5440 WADE PARK BLVD, SUITE 102 WWW.BGEINC.COM NC LICENSE #C-4397 ©2023	DESIGNED BY:				
	DRAWN BY:				
	REVIEWED BY:		DF		
			DF/JWM	10/02/2023	PER TOWN OF ROLESVILLE COMMENT
				08/01/2023	PER TOWN OF ROLESVILLE COMMENT
		REV	06/01/2023	INITIAL SUBMITTAL

PARKER RIDGE
82 SCHOOL STREET
ROLESVILLE / NORTH CAROLINA / 27571

CARVED STREET CT PLAN
AND PROFILE

C6-16

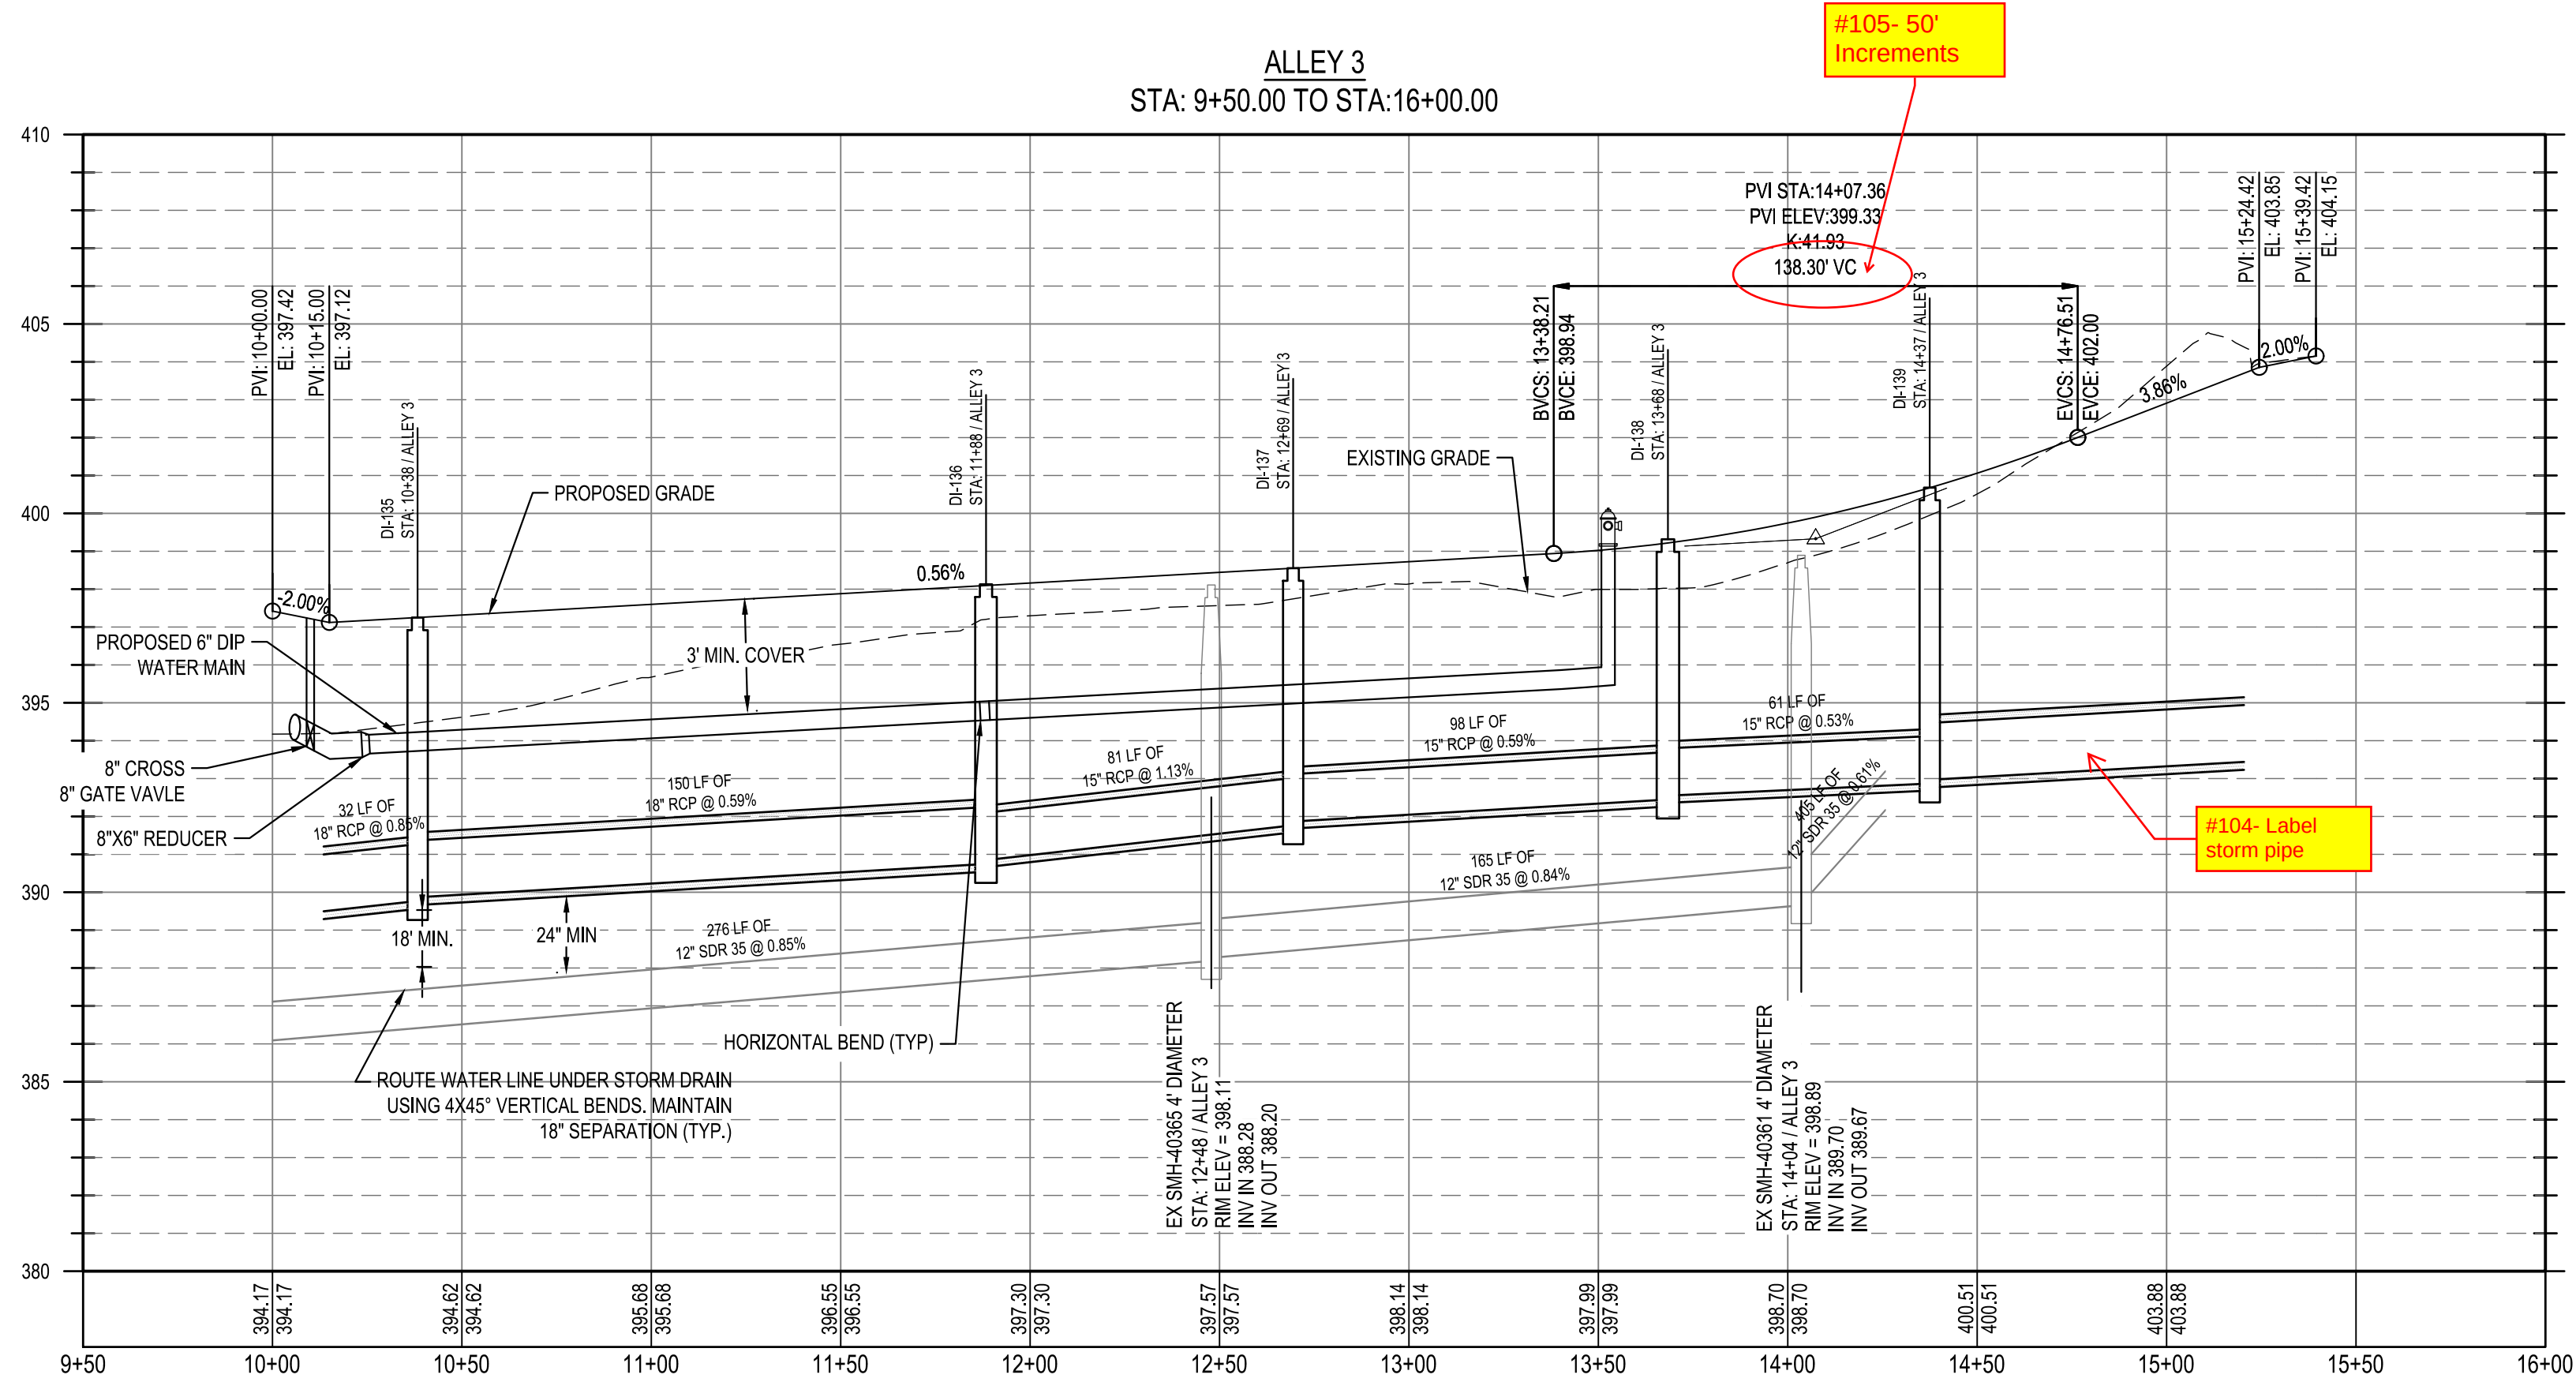
#104- Label cross and reducer

GW2 GREENWAY PLAN AND
PROFILE (2 OF 2)

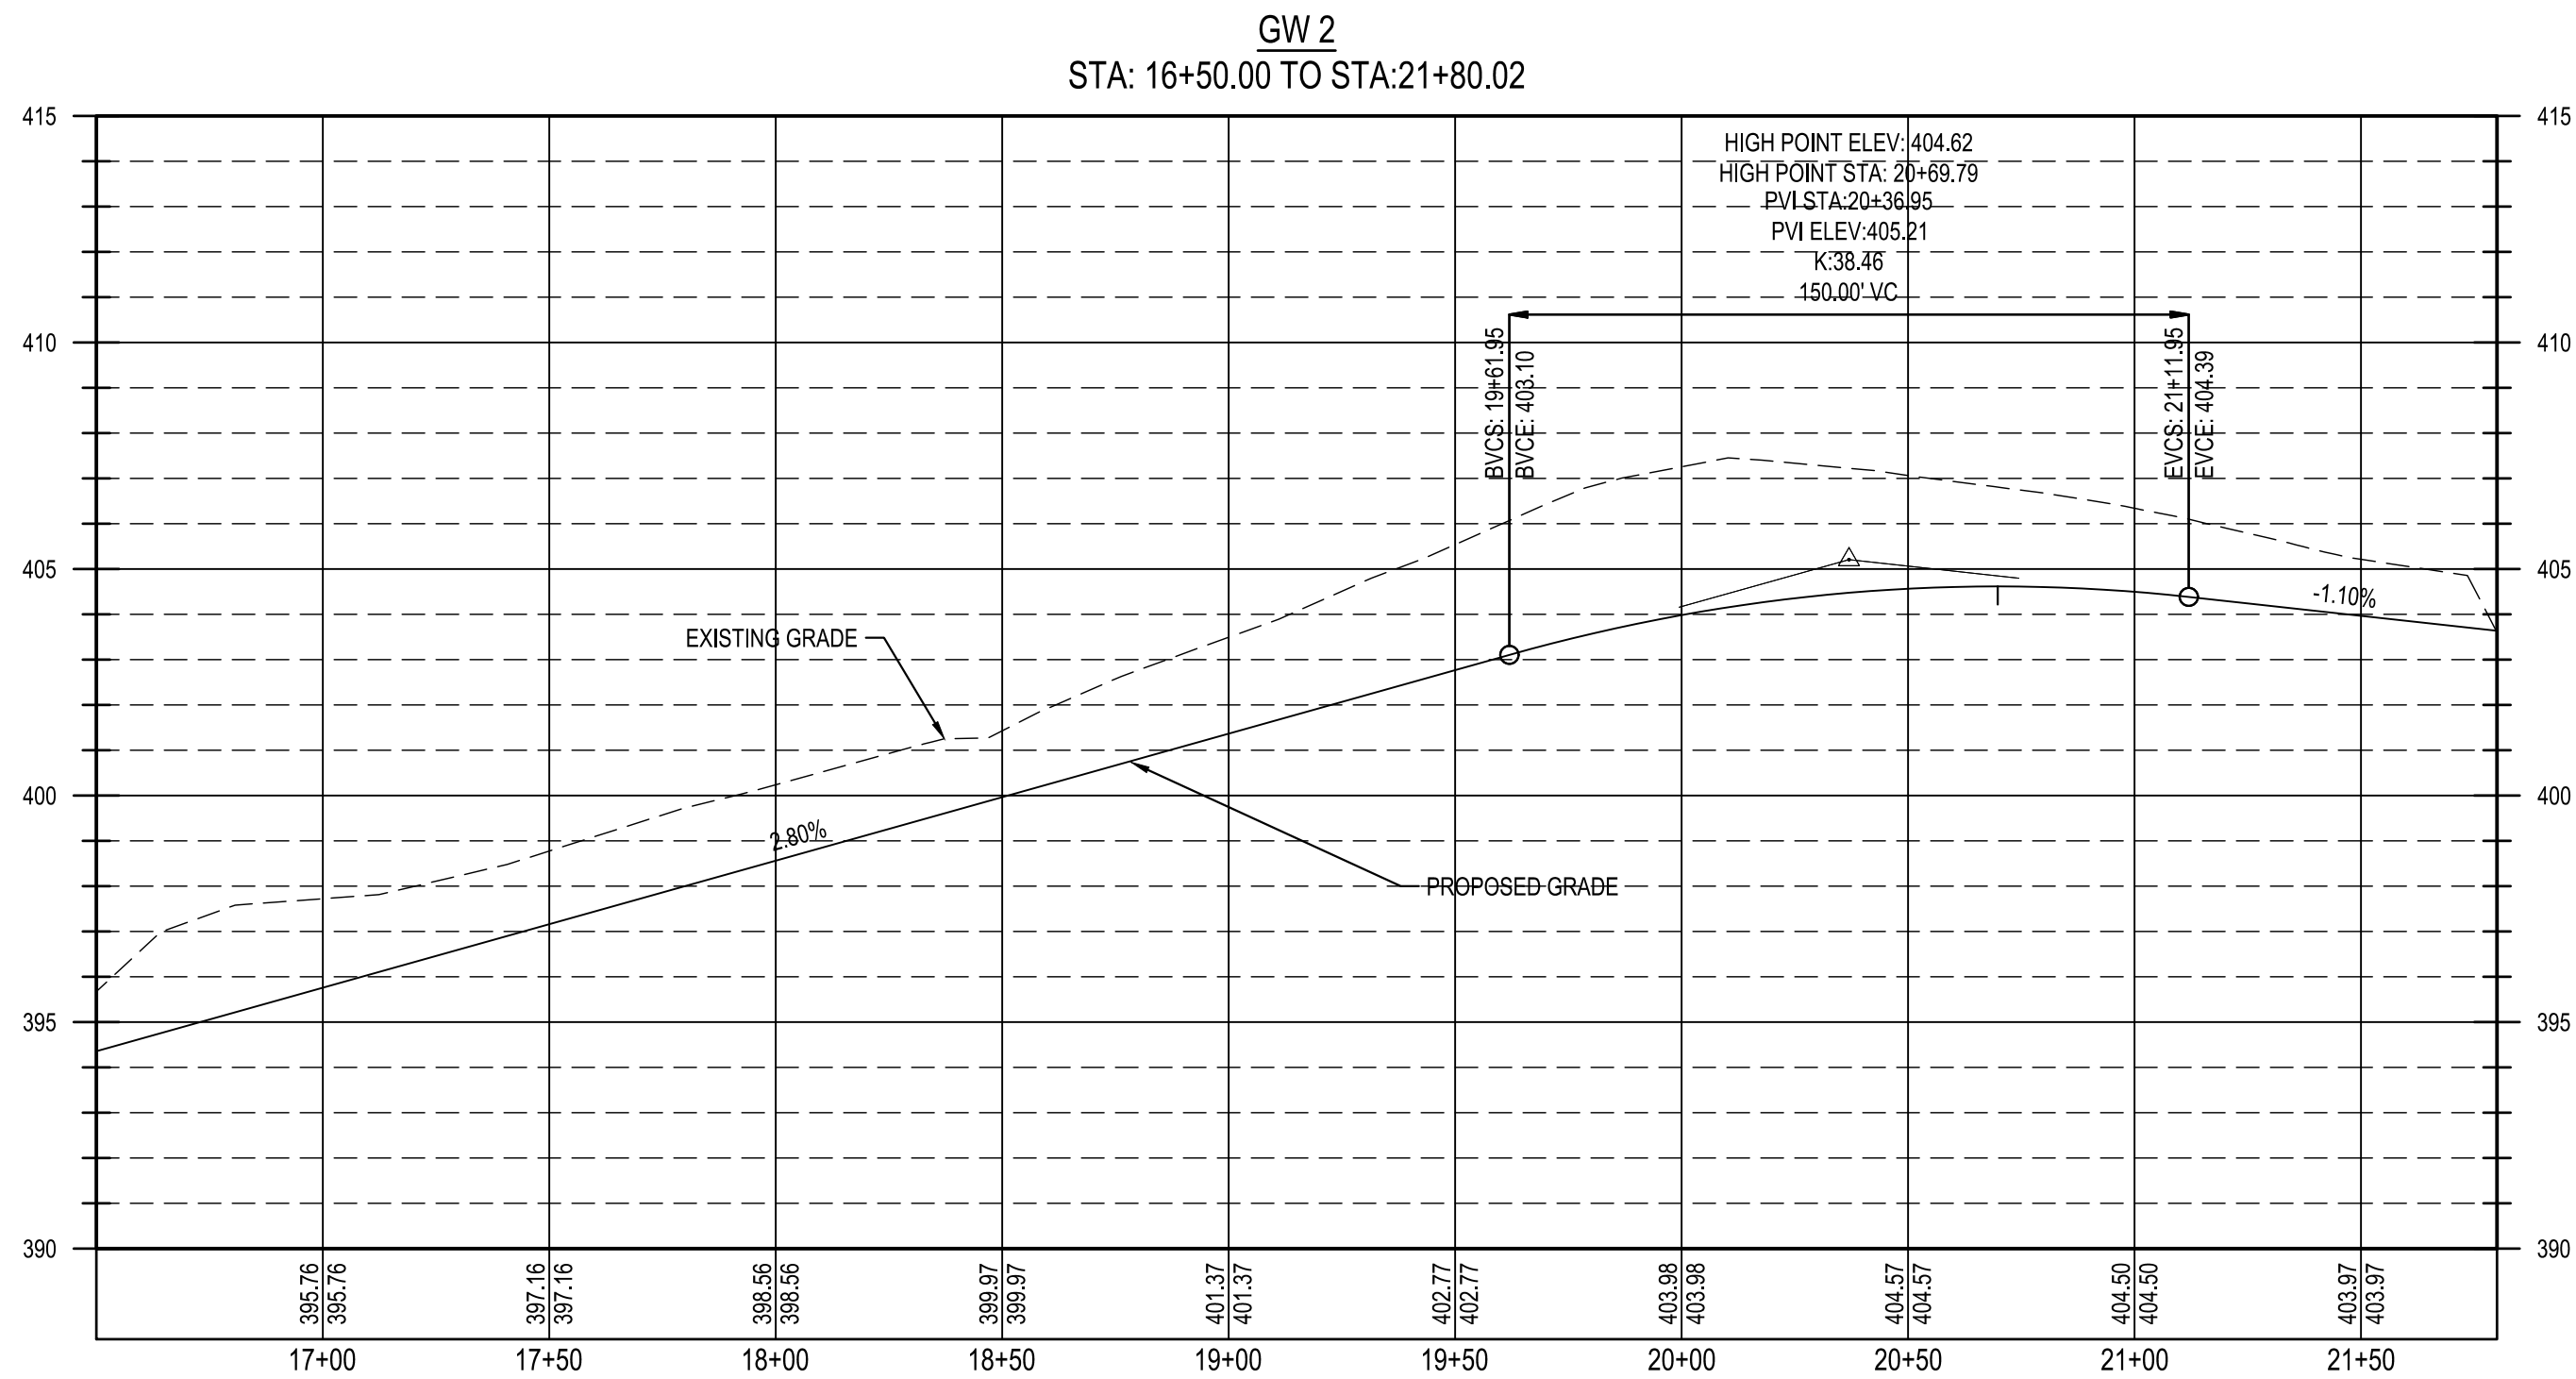
#48- Add proposed contour labels
